# SERVICE BULLETIN

## SB-07-015

### Super Doubles Trailers | Trailers Manufactured out of Glade Springs, VA between Jan 2006 to May 2021

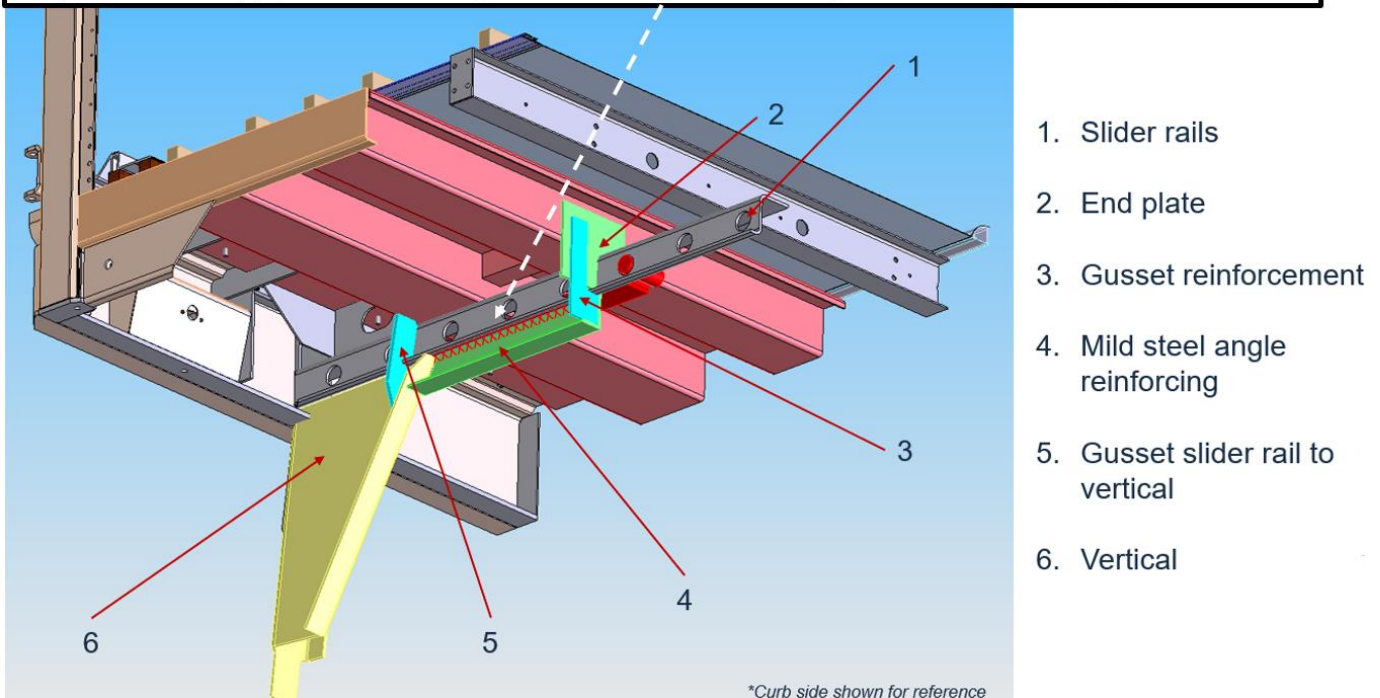
**RECALL NOTICE:** Trailers manufactured out of Glade Springs, VA factory for Super Doubles operation may be missing a horizontal weld attaching a mild steel angle to the slider rail just above the pintle hook tube assembly.

Inspect if weld is present. Weld can be located on the INSIDE (between the slider rails) or OUTSIDE. If weld is not present, ok to apply  $\frac{1}{4}$ " weld full length as shown to OUTSIDE mating surface of mild steel angle to slider rail.
